TROPICAL TIMBER PLANTATIONS BEAGLE BAY PROJECT

PUBLIC ENVIRONMENTAL REVIEW SUBMISSIONS RESPONSES

MAY 2005

JOHN BRENNAN AND ASSOCIATES Project Managers		Client:	TROPICAL TIMBER PLANTATIONS PTY LTD	PLANTATION DEVELOPMENT PLAN 100 ha PLOT WITH 80m WIDE HABITAT CORRIDORS	Date: 8 March 2004
		Project:	BEAGLE BAY PROJECT		Scale: 1: 50 000
Author: J.B. / S.C.	Drawn: S.Coleman				
				A4	Plan No. BB-008

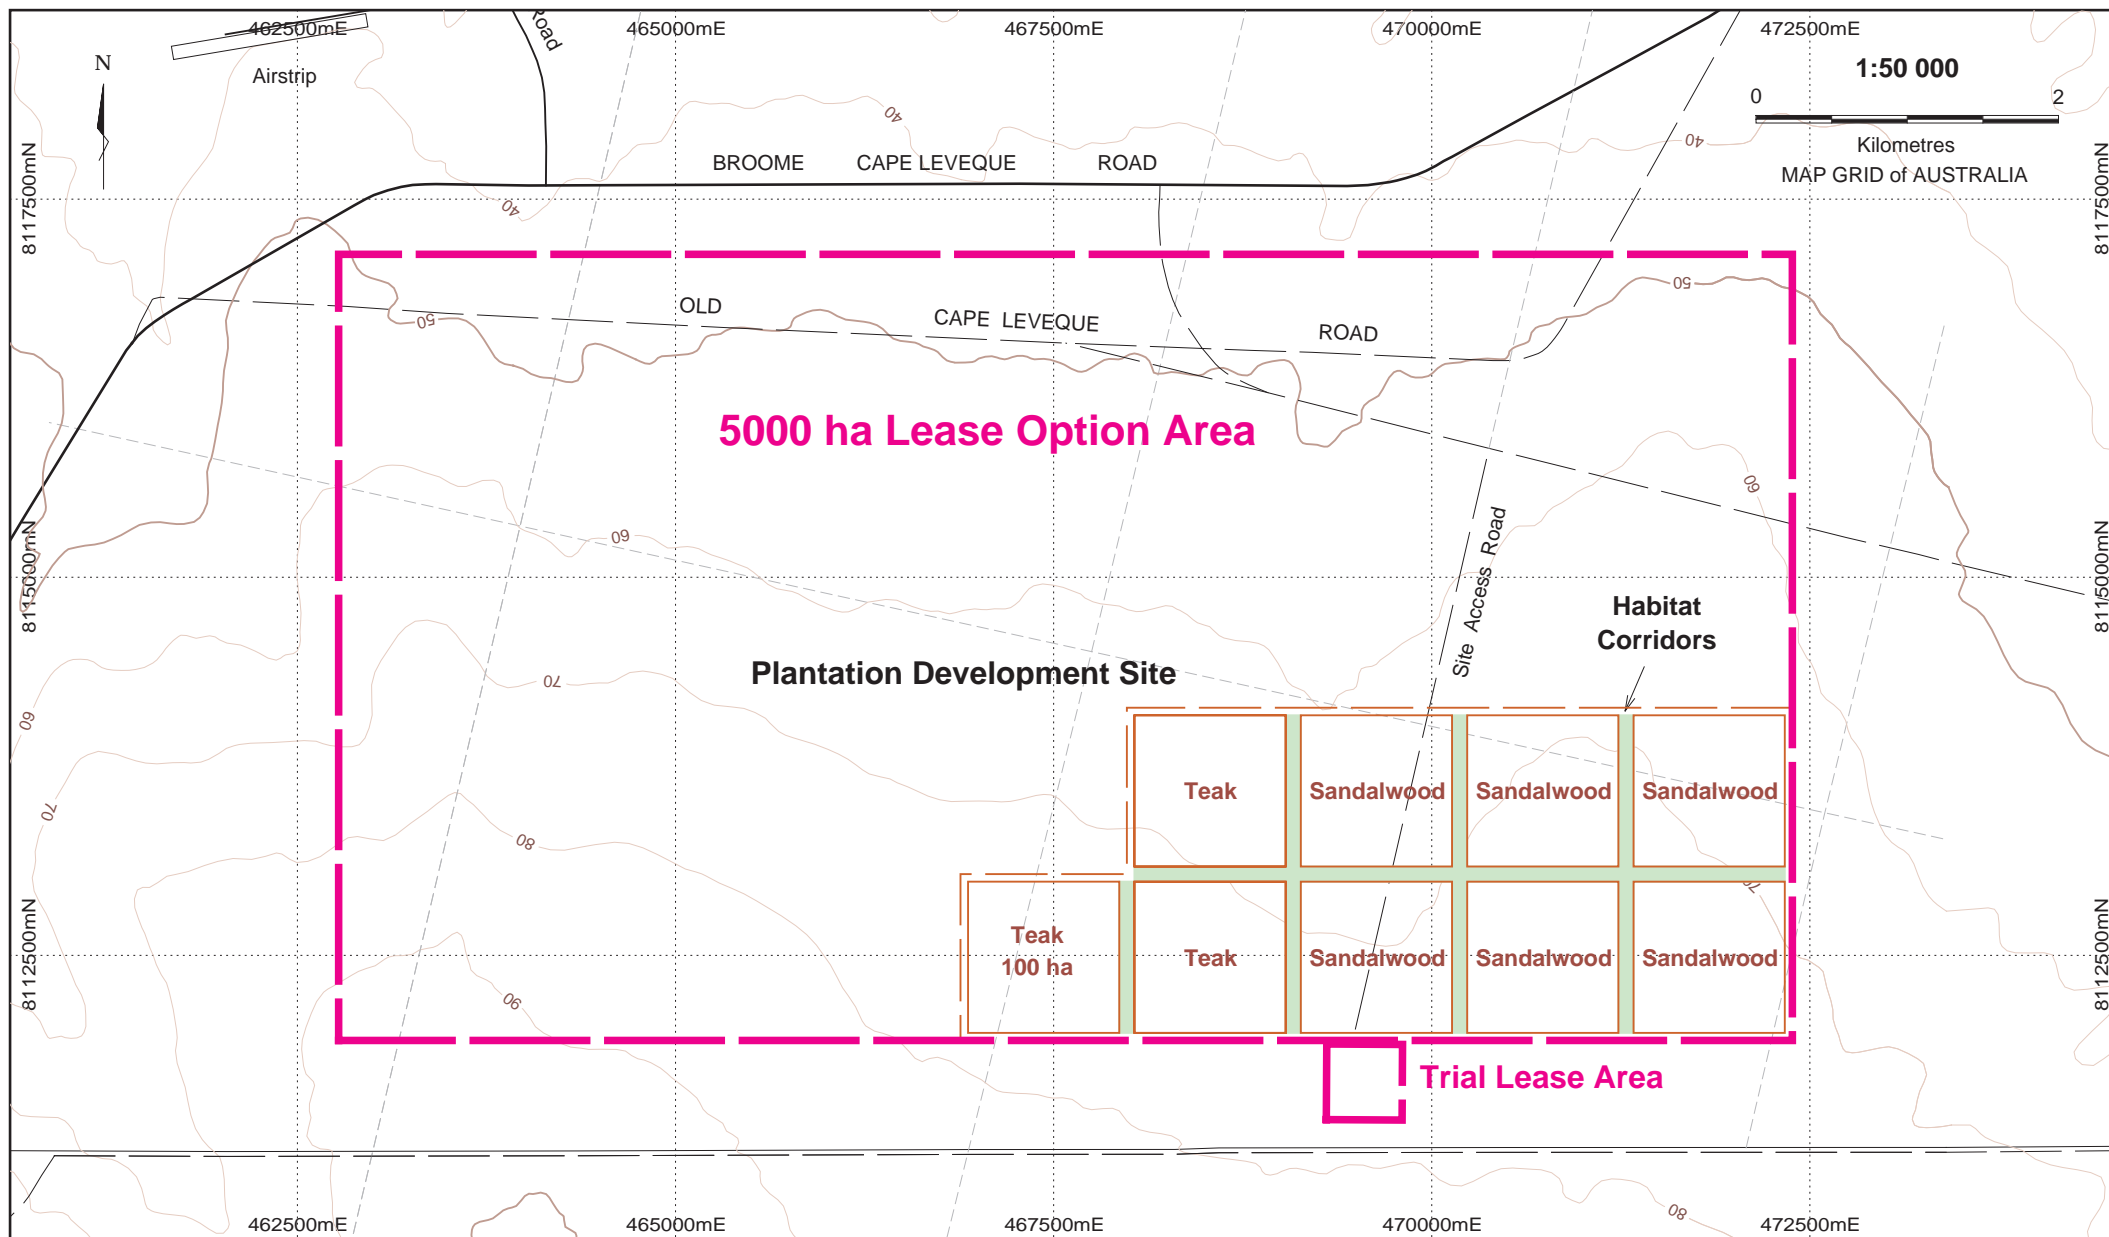
Figure 3.1 shows the plantation layout in stage 2, ie 15 plots of 100 ha each . It does not provide information for the layout of stage 1. Two separate figures should be provided – one for stage 1 and another for stage 2. The borefield should also be indicated. Other figures are also titled: stage 2 expansion, but the figures do not indicate this. This discrepancy serves to confuse and makes it difficult to read the diagrams.

a) The PER is poor. It is repetitive and inconsistent. Most worryingly, it shifts from 900 ha proposal to a 1,500 ha proposal, sometimes without changing the figures. For example, the workforce for a 900 ha plantation is said to be 25, the project life span 20 years and the anticipated year of project closure 2025 (p.xii) exactly the same figures for a 1,500 ha plantation (p. 147). The PER says that 9 X 100 ha plots will be arranged as depicted in Figure 3.1 (p.12), but Figure 3.1 depicts 15 plots of 100 ha, ie 1,500 ha (p. 15).

Response: *The Proponent acknowledges that many of the figures were confusing and has corrected the figures to relate to Stage 1 of the project only. These revised figures are provided in Appendix A.*

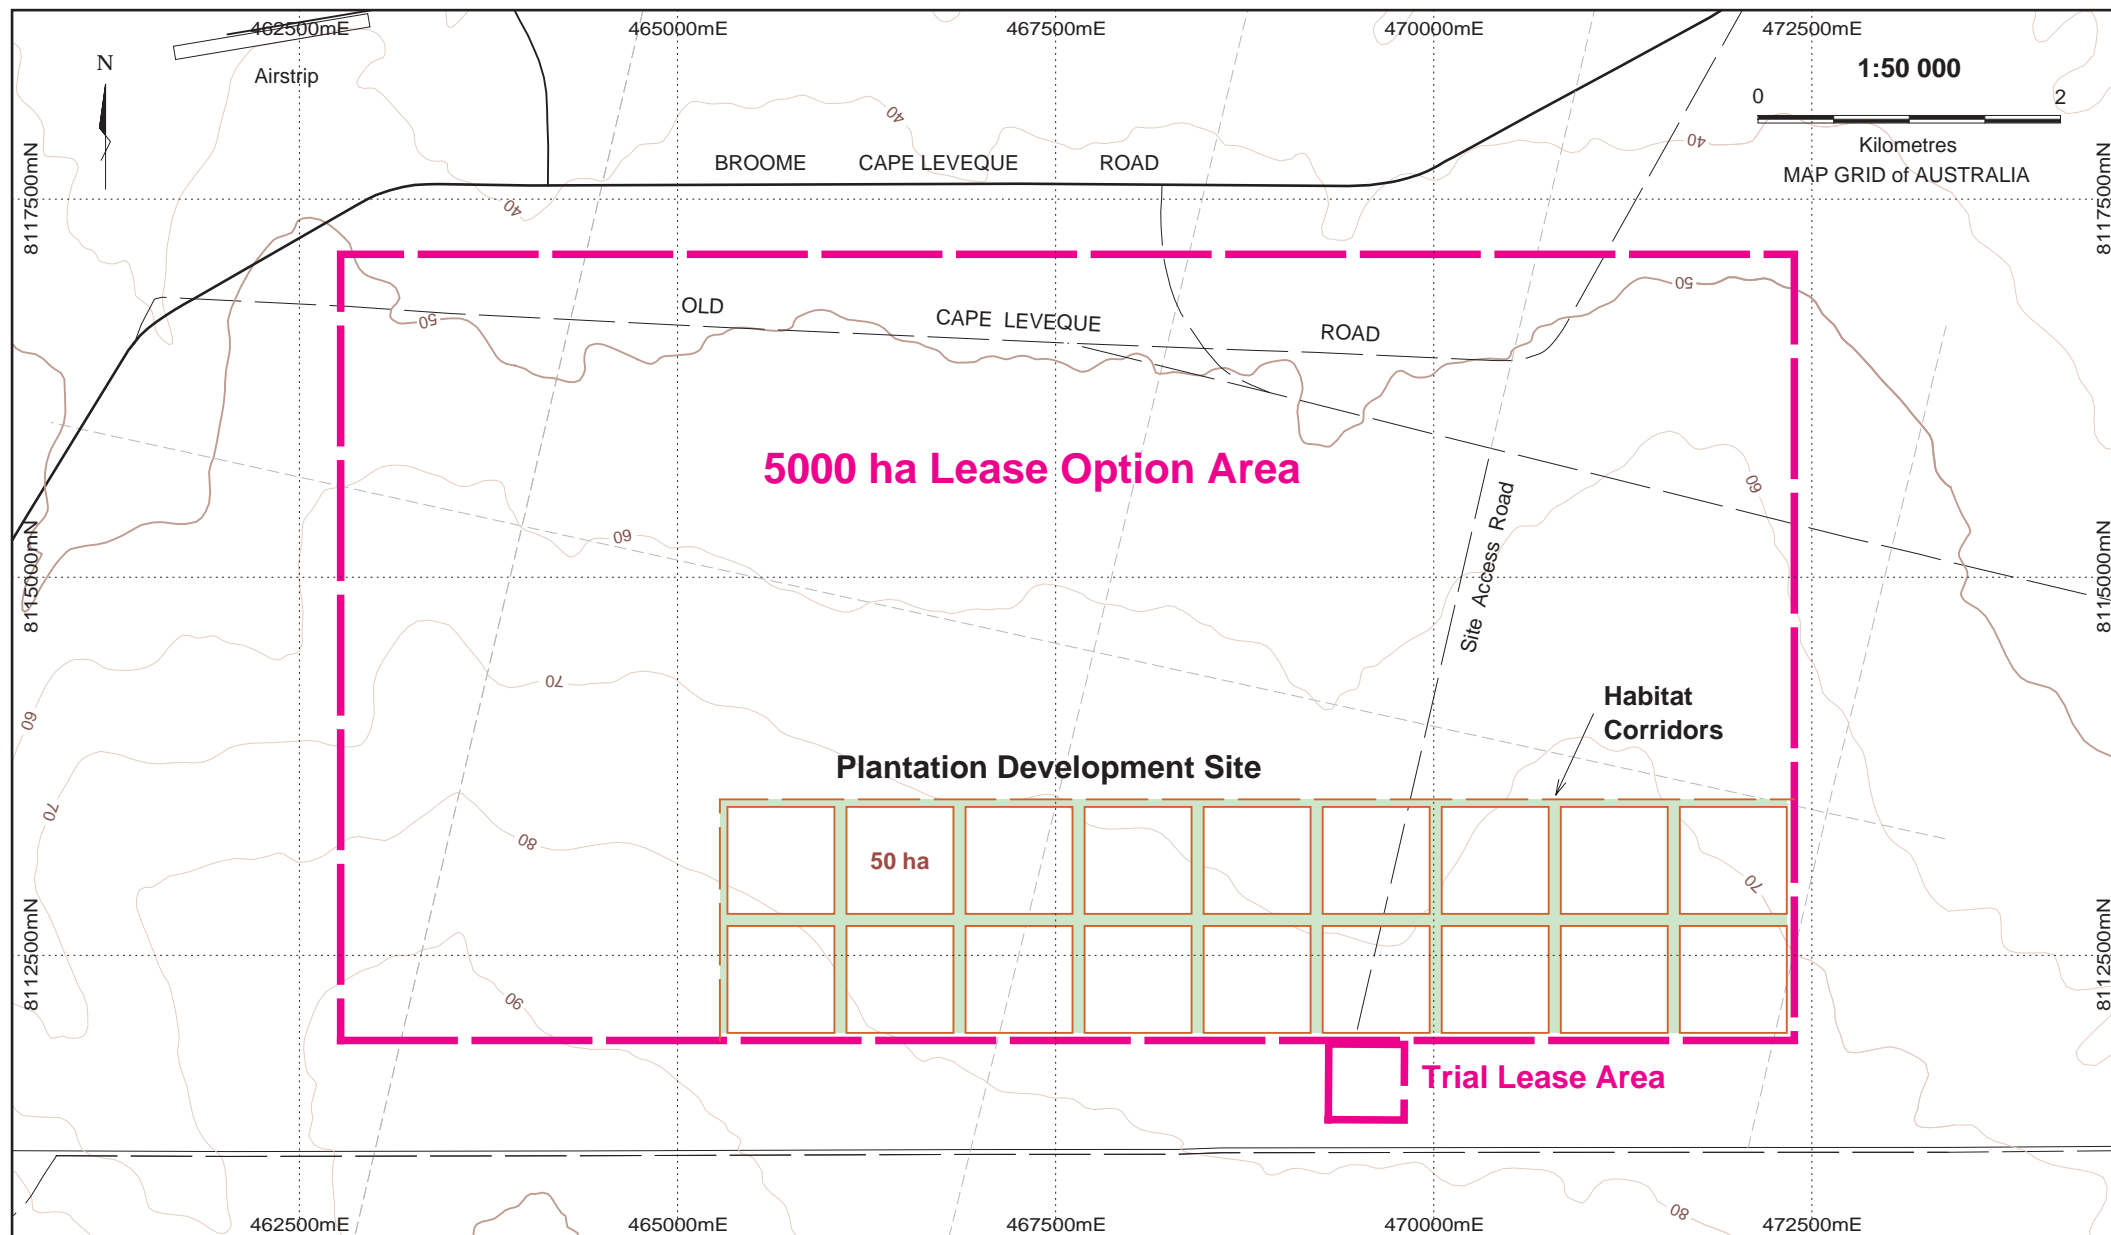
Figure 3.2 is titled ‘proposed stage 2 expansion, but the diagram is of stage 1 plots only (ie 900ha cleared). This needs to be corrected to avoid confusion. Suggest two figures are provided – for stage 1 and stage 2.

JOHN BRENNAN AND ASSOCIATES		
Plot Layout		
A3		
Client:	TROPICAL TIMBER PLANTATIONS PTY LTD	Date: 10 August 2005
Project:	BEAGLE BAY PROJECT	Scale: 1: 5 000
Author: J.B. / S.C.	Drawn: S.Coleman	Figure No. 3.3
		Plan No. BB-019

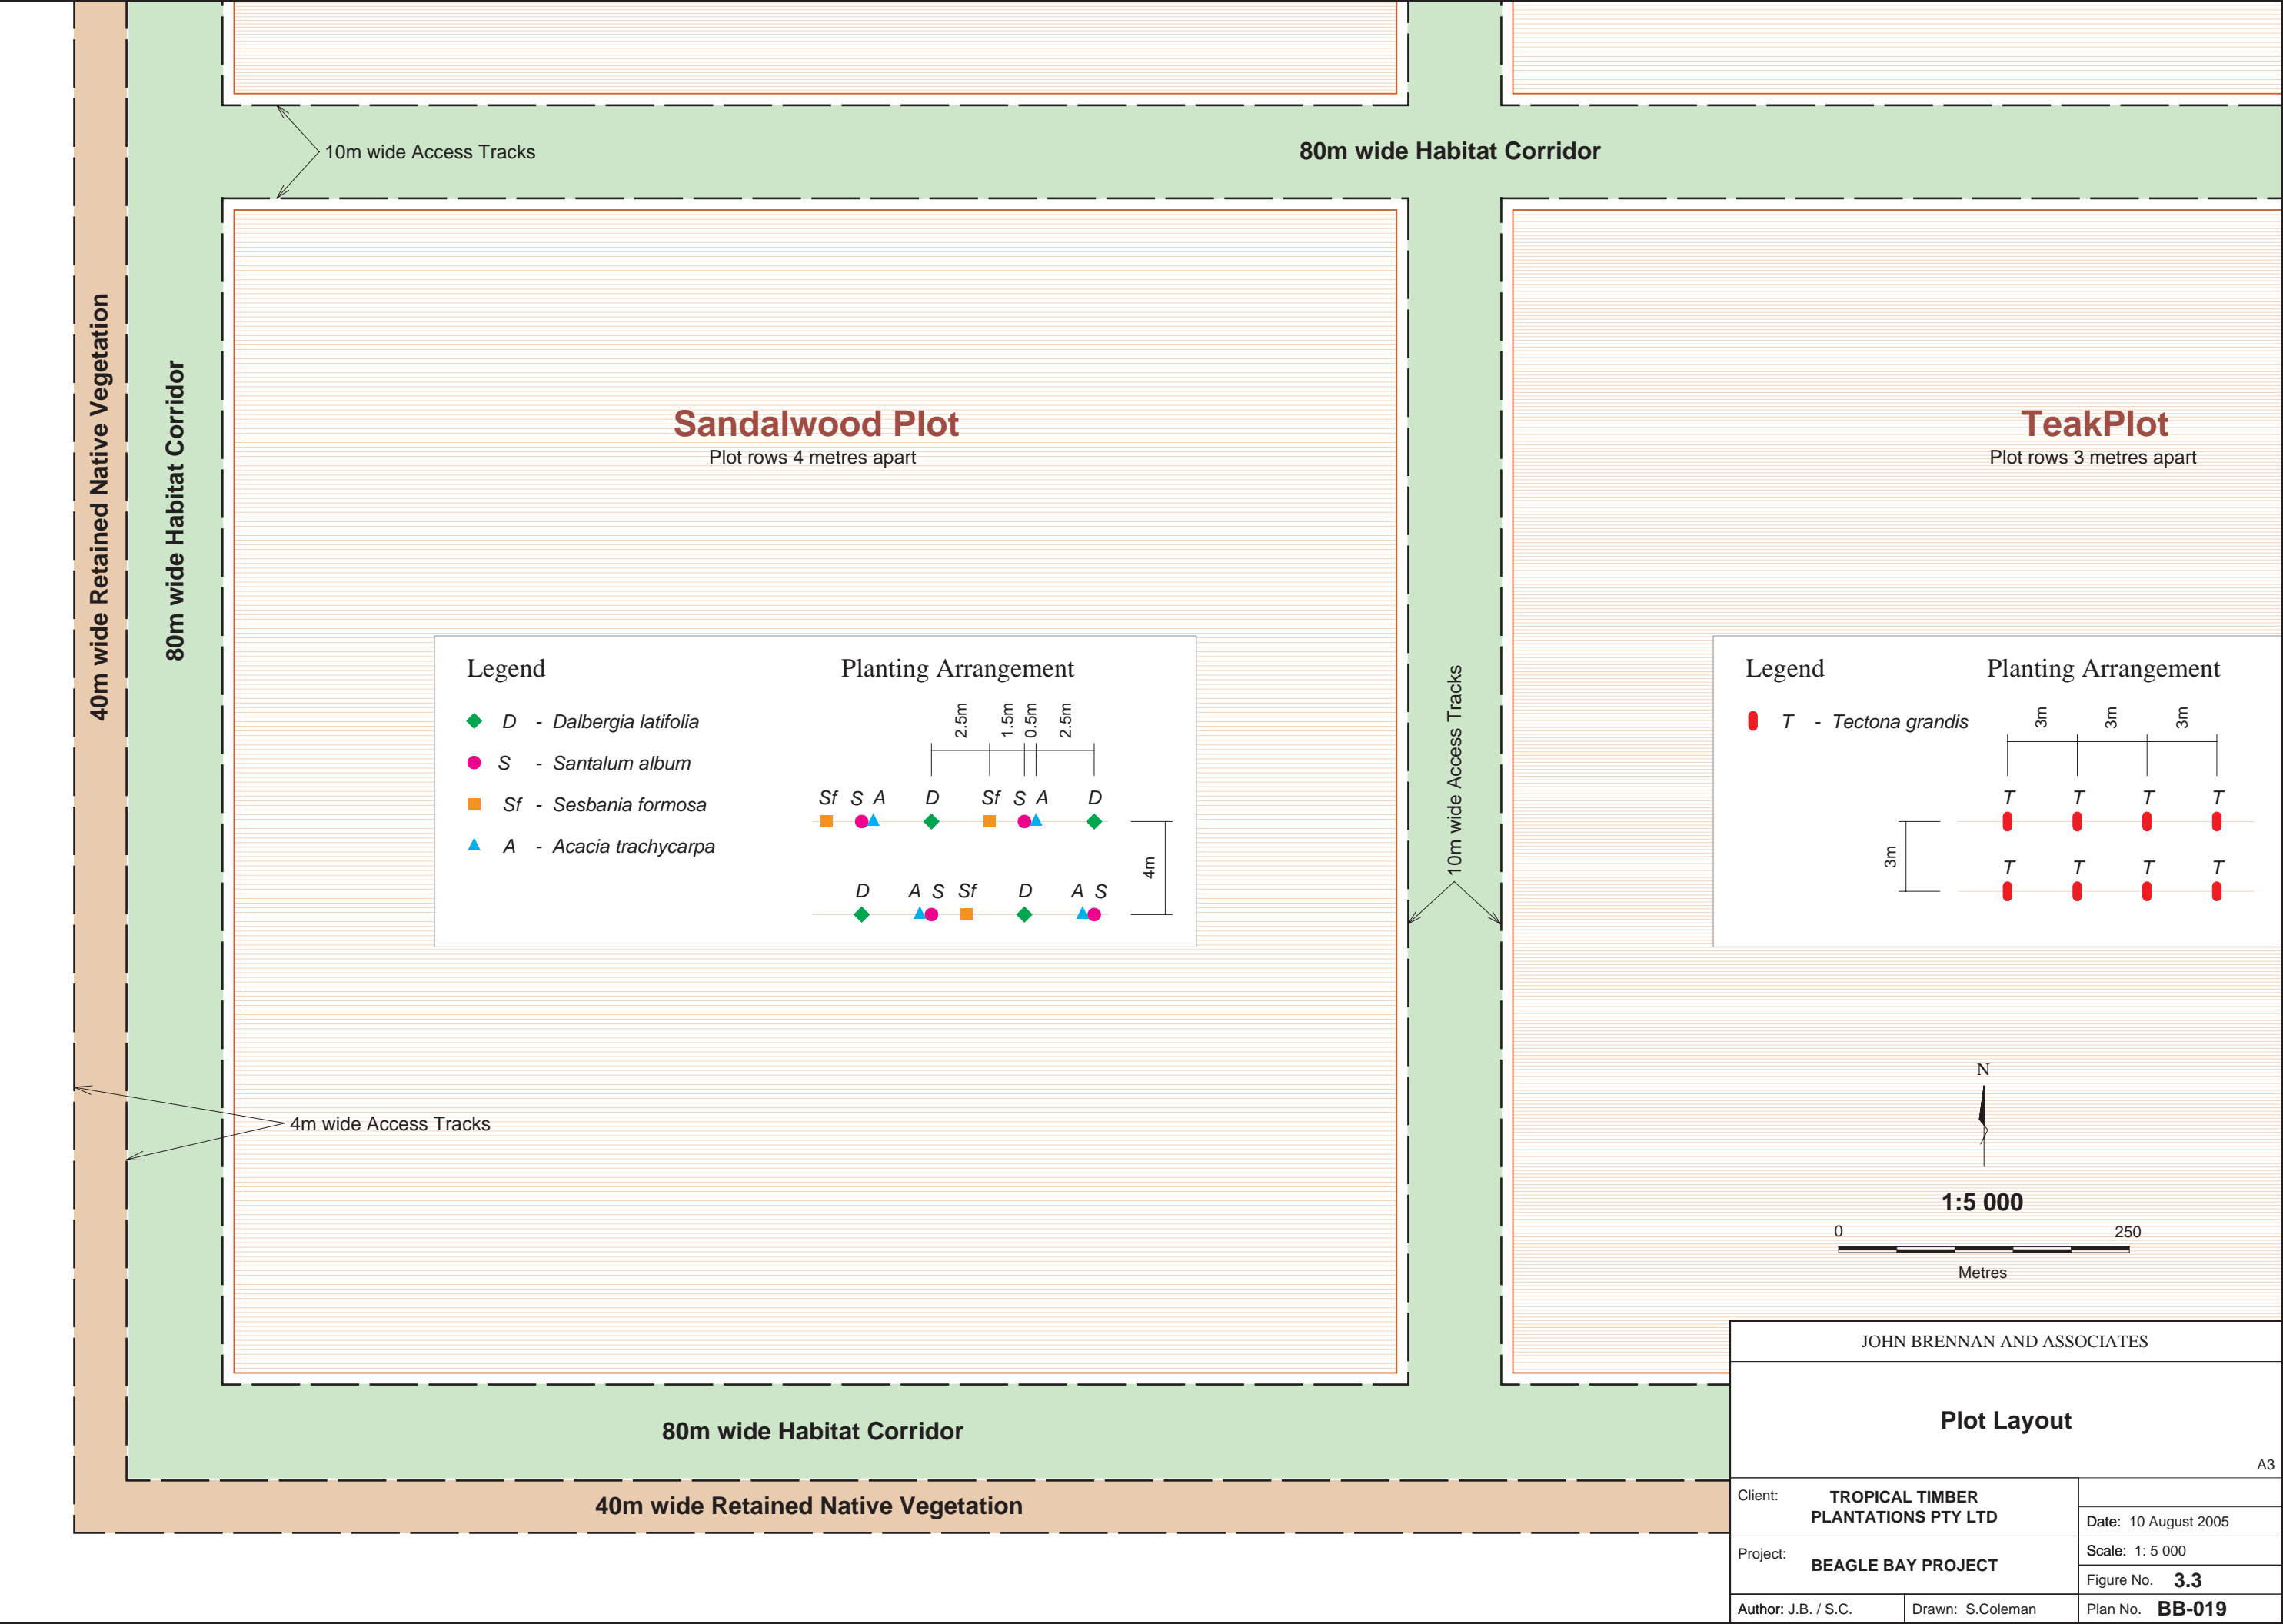
What is the difference between bush corridors and wildlife corridors, as in Figure 3.3?

Response: *See response above and refer to Figure 3.3 in Appendix A.*

Response: *TTP commit to minimum habitat corridors of 80 m wide. The arrangements of the corridors are detailed in the attached Figure 3.3 (Appendix A).*
